**REDESIGN OF REACHES A AND B  
OF THE LOWER CALERA CREEK ELEMENT**

**FIRST ADDENDUM TO THE  
LOWER BERRYESSA CREEK PROGRAM  
FINAL ENVIRONMENTAL IMPACT REPORT  
SCH# 2007092084**

**July 2018**

Figure 2: Drawings Showing Civil Design of The Lower Calera Element

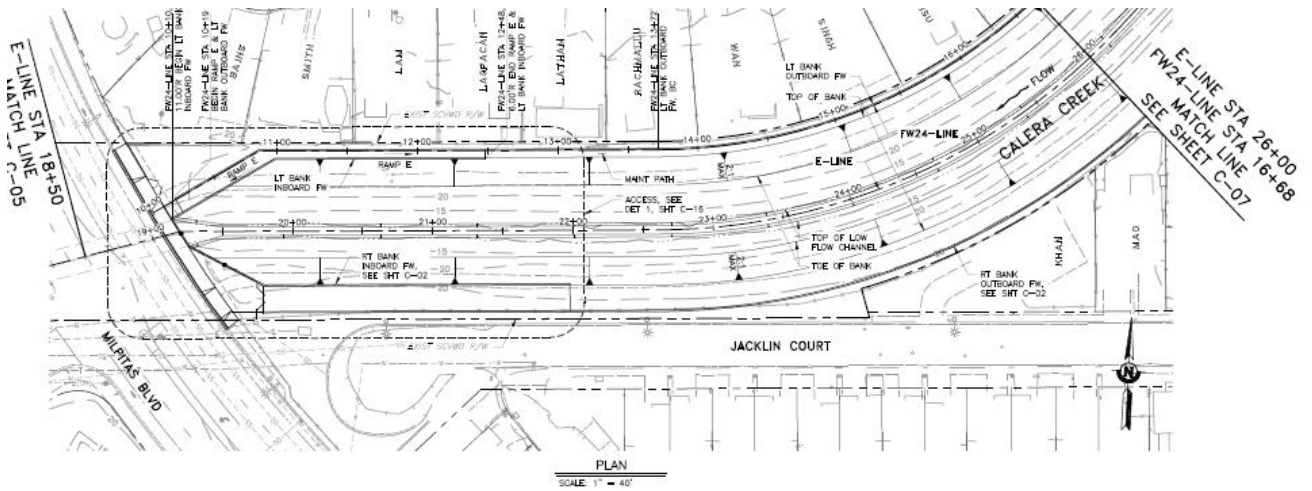
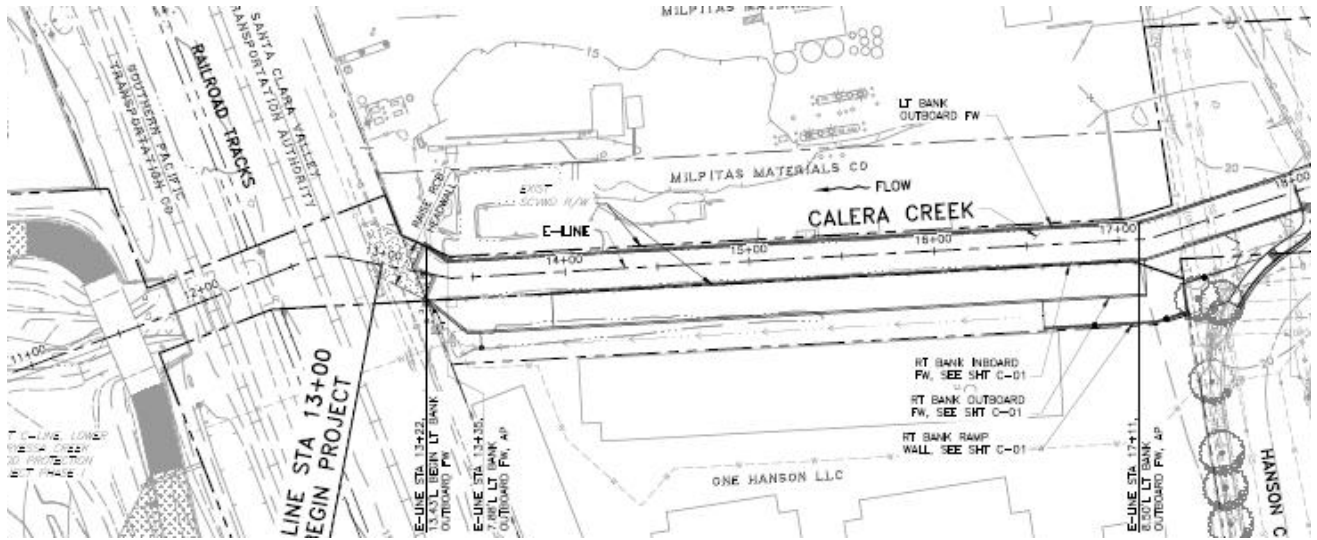
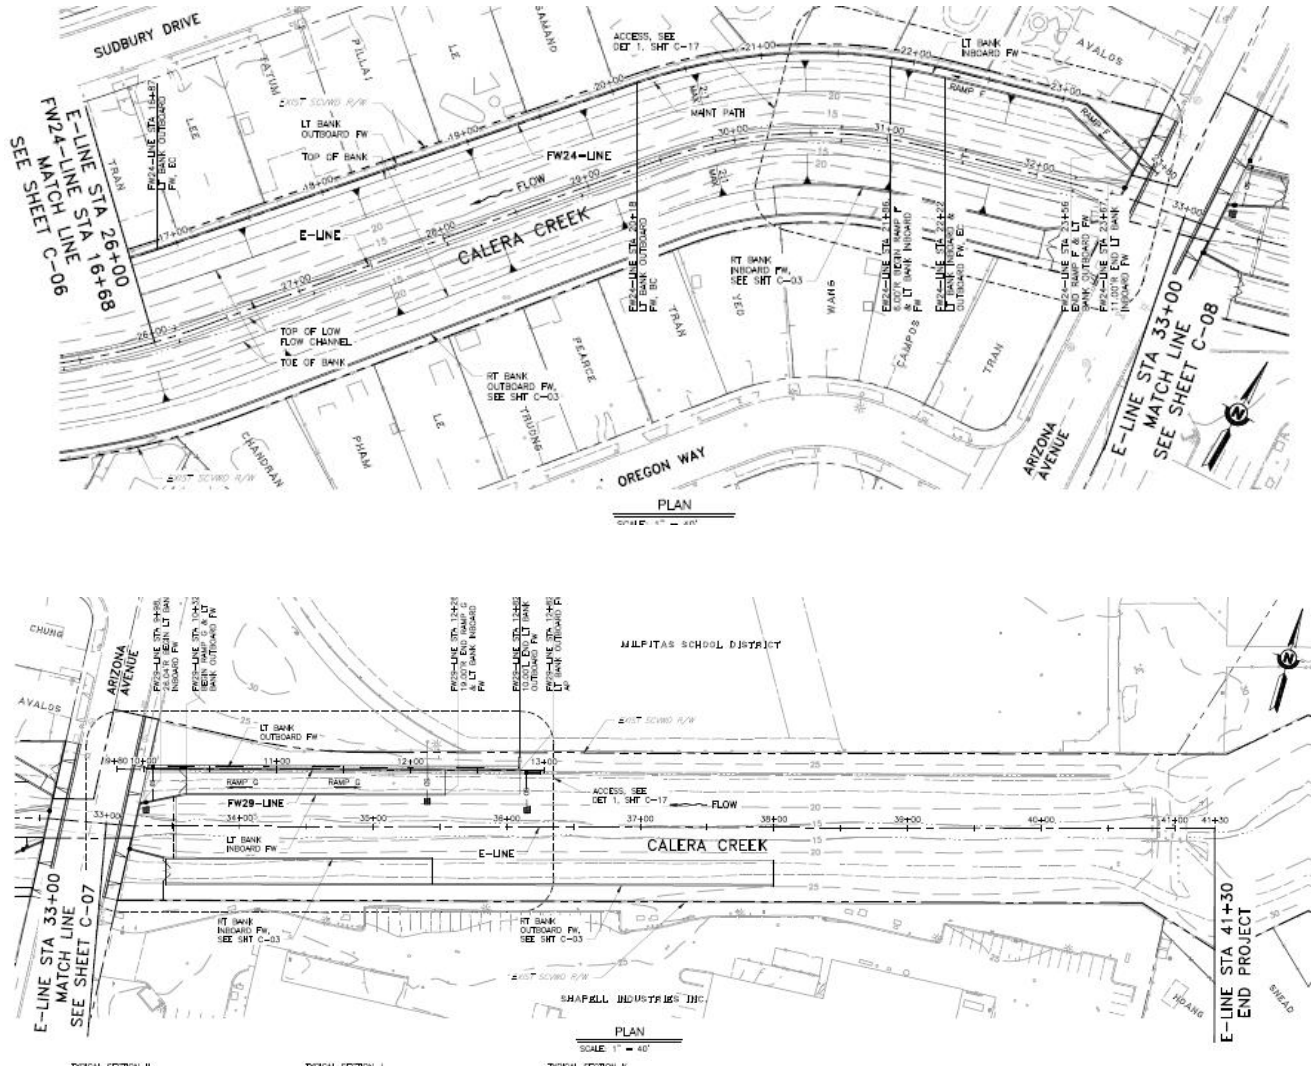
**Reach A:** This reach, extending from the Union Pacific Railroad Bridge upstream to N. Milpitas Boulevard, contains an existing roughly 500-ft long concrete U-frame structure that lines the channel bed and banks (see Figures 1 and 3). The element design analyzed in the 2011 EIR retained the existing concrete U-frame and raised the height of the walls by 4 feet to increase flow conveyance capacity. It also included a new top-of-bank channel access road on the south side of the U-frame. However, recent structural analysis found that the existing U-frame is not competent to support the proposed raised walls; therefore, the U-frame must be replaced to increase capacity to pass the 1% flow. The district proposes to demolish and remove the existing U-frame and construct a new concrete U-frame structure and channel access road/ramp in Reach A. (See Figure 2). The modified creek channel would include a maintenance road and ramp accessing the channel on the south bank of the creek, and a 10-ft tall head wall (elevation 17.5 ft to 27.5 ft North American Vertical Datum 1988 [NAVD88]) on the existing railroad bridge at the downstream end of the U-frame. After construction is complete, the creek bed within the U-frame would be concrete lined under both the EIR/permitted design and the proposed redesign. However, the concrete bed of the redesigned channel would be lower than the existing concrete bed lining (which would be removed) and one foot of soil would be placed over the concrete bed lining to create a soft channel bottom. Sediment accumulates in this section of channel under

Demolition of the U-frame would generate about 672 CYs of concrete debris that would be disposed of at a licensed off-site disposal area. About 2,355 CY of concrete would be used to construct the new U-frame and adjoining retaining wall for the channel access road/ramp, compared to 140 CYs of concrete placed under in this reach under the permitted design. Thus, the redesigned project would require about 2,215 CYs more concrete than the EIR/permitted design.

**Reach B:** This reach contains an existing roughly 2,200 ft long trapezoidal earthen channel and existing bridges at the N. Milpitas Boulevard and Arizona Avenue creek crossings (see Figure 4). For Reach B, the project EIR analyzed the following design components:

Recent modelling of the creek flows shows that is not necessary for the Reach B floodwalls to extend to the upstream Reach limit (i.e. the existing drop structure adjacent to Milpitas High School) to provide 1% flow capacity. The redesign includes 1,560 linear ft of floodwall on the north bank and 1,370 linear ft of floodwall on the south bank. The total length of Reach B floodwalls would be 2,930 ft, which is 1,470 ft (33%) less than the 4,400 linear ft of floodwalls in the 2011 EIR project. The floodwalls, similar to the 2011 EIR project, would be constructed on the crest of the existing earthen levees on either side of the creek channel. The proposed floodwalls would be taller than the 2011 EIR project floodwalls which were described as up to 6.5 ft in height. The redesigned floodwalls would range up to 8.5 ft in height above the levee crest (aka ground surface) on the north and south banks. Elevation of the floodwalls would range from 20.0 to 28.5 ft NAVD88 for the wall section between N. Milpitas Blvd. and Arizona

The amount of concrete used to construct the floodwalls and footings would decrease by 35% (from approximately 810 CY to approximately 530 CY) and floodwall footprint area would decrease by 38% from approximately 0.32 ac to approximately 0.2 ac.

The existing concrete box culverts at both the N. Milpitas Blvd. and Arizona Avenue crossings would not be changed and would remain in place. About 3,600 square feet of in-channel sacked concrete located upstream of the N. Milpitas Boulevard culvert and upstream and downstream of the Arizona Avenue culvert would be removed. About 1,500 sq. ft. of one-quarter ton rocks would be placed at the upstream entrance to the N. Milpitas Blvd. culvert to prevent erosion.

Headwalls on the N. Milpitas Blvd. bridge would be raised in height. The existing headwalls have crest elevations of 21.8 ft NAVD88. New concrete headwalls would be constructed at the upstream and downstream face of the bridge and would tie into floodwalls on both banks. The upstream headwall would be 8.7 ft in height (19.8 to 28.5 ft NAVD88). The downstream headwall would be 6.7 ft in height (20.8 to 27.5 ft NAVD88). The upstream and downstream headwalls would be 6.7 ft and 5.7 ft, respectively, taller than the existing N. Milpitas Blvd. bridge headwalls.

Headwalls on the Arizona Avenue. bridge would also be raised in height. The existing headwalls have crest elevations of 23.6 ft NAVD88. New concrete headwalls would be constructed at the upstream and downstream face of the bridge and would tie into floodwalls on both banks. The upstream headwall would be 6.5 ft in height (22.5 to 29.0 ft NAVD88) and the downstream headwall would be 6.2 ft in height (22.3 to 28.5 ft NAVD88). The upstream and downstream headwalls would be 5.4 ft and 4.9 ft, respectively, taller than the existing Arizona Avenue bridge headwalls.
